Roadway Plans_V1.pdf Markup Summary

CLEARWAY FILING NO. 2, LOT 5		TITLE SHEET	
PROJECT NO. 44-042A		DATE: 06-02-2022	
DESIGNED BY: DLM		SCALE: HORIZONTAL: N/A	
DRAWN BY: CLP		VERTICAL: N/A	
CHECKED BY: DLM		SHEET 1 OF 15	
212 N WAHSATCH AVE, STE 305 COLORADO SPRINGS, CO 80903 PHONE: 719.955.5485		TS01	
FOR AND ON BEHALF OF M&S CIVIL CONSULTANTS, INC.			
VIRGIL A. SANCHEZ, COLORADO P.E. NO. 37160			
REVISIONS:			
NO.	DATE	BY	DESCRIPTION
THE ENGINEER PREPARING THESE PLANS WILL NOT BE RESPONSIBLE, OR LIABLE FOR, UNAUTHORIZED CHANGES TO OR USES OF THESE PLANS. ALL CHANGES TO THE PLANS MUST BE IN WRITING AND MUST BE APPROVED BY THE PREPARE OF THESE PLANS.			
CAUTION

FULL SPECTRUM DETENTION SAND FILTER POND 1

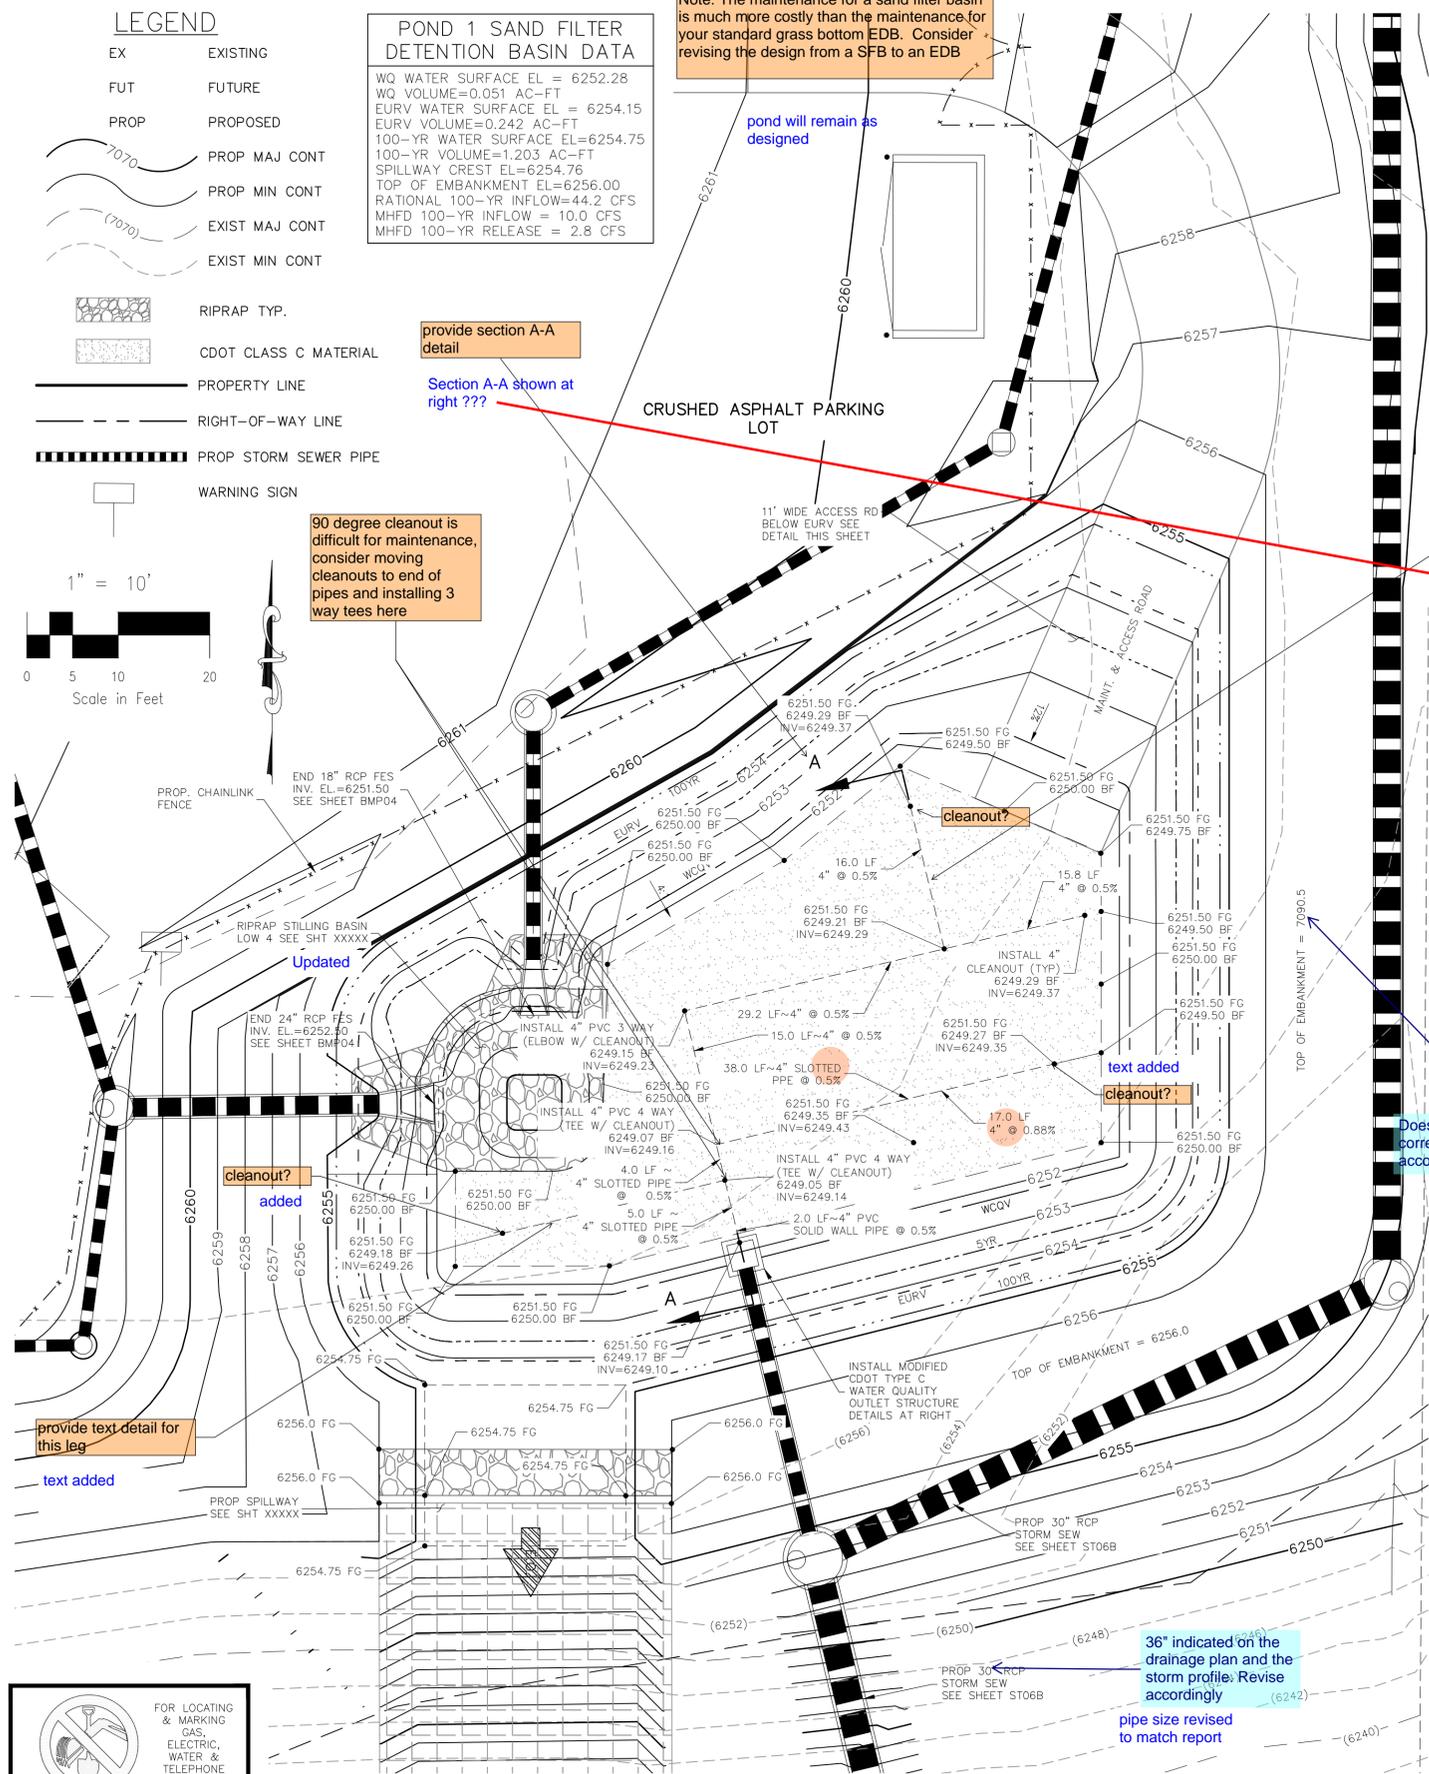
Note: The maintenance for a sand filter basin is much more costly than the maintenance for your standard grass bottom EDB. Consider revising the design from a SFB to an EDB

provide section A-A detail

Figure 9-37. Low tailwater riprap basin

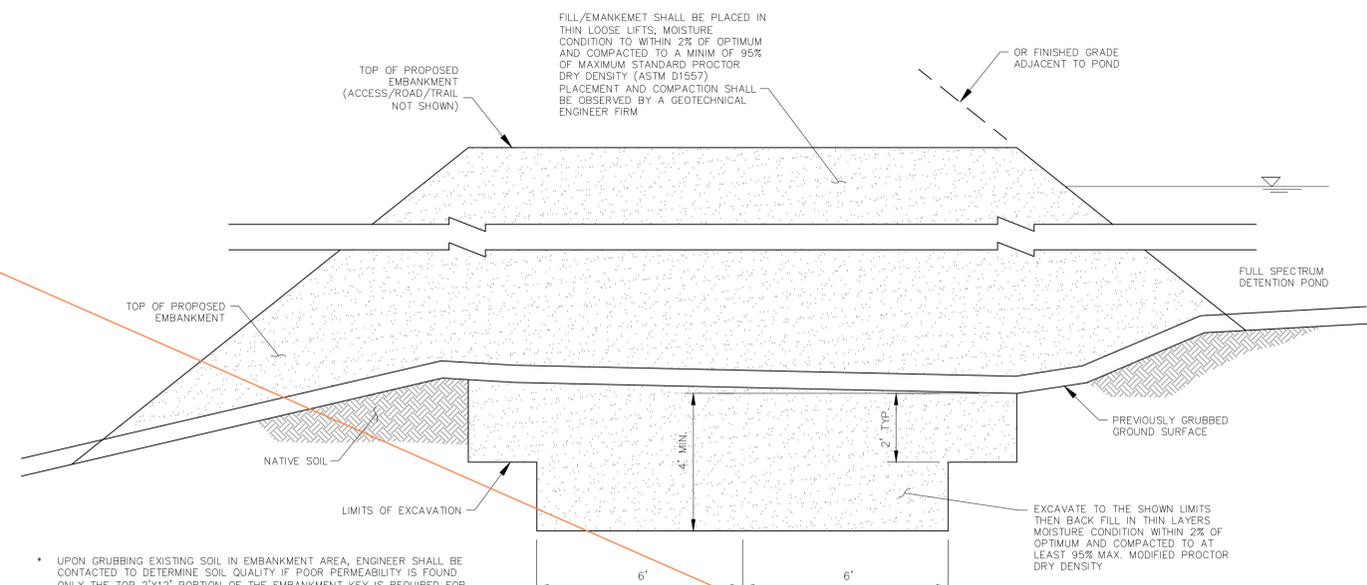
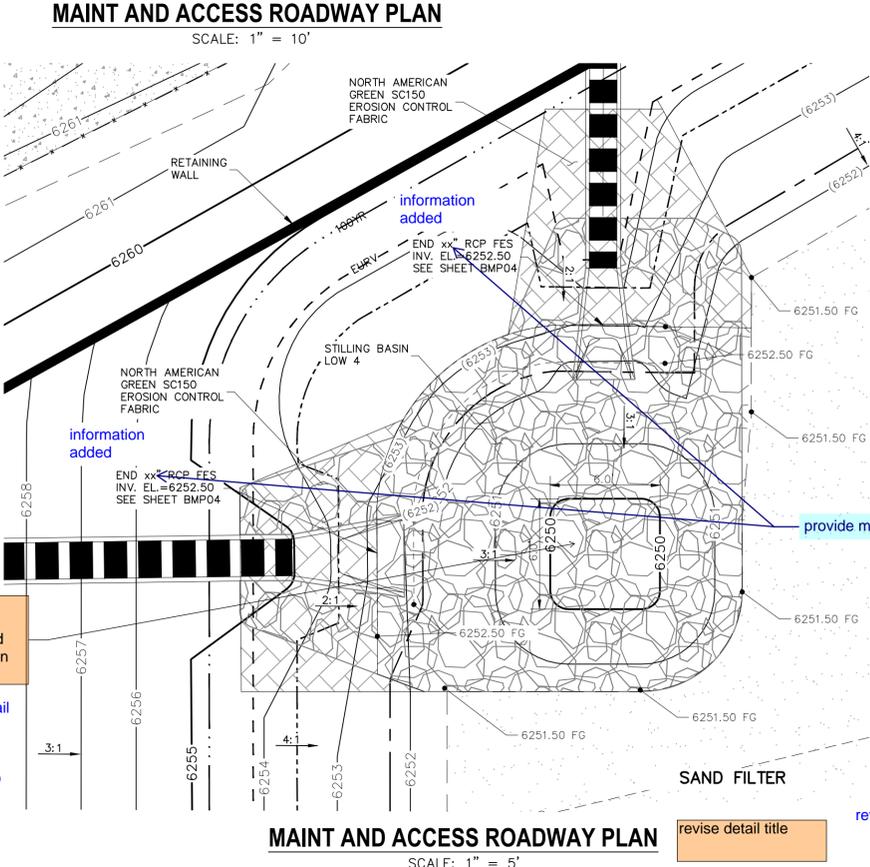
Stabilized access ramp shall be a minimum of 15ft wide and no greater than 12% slope, in accordance with DCMv1, Chap 11.2.2. --Unless the anticipated maintenance vehicles and equipment can safely access the pond at specified road width. Properly document this in the Pond O&M manual.

provide sizing calculations in drainage report and show dimensions on plans
sized per detail at right there are enough dimensions to adequately construct

revise detail title
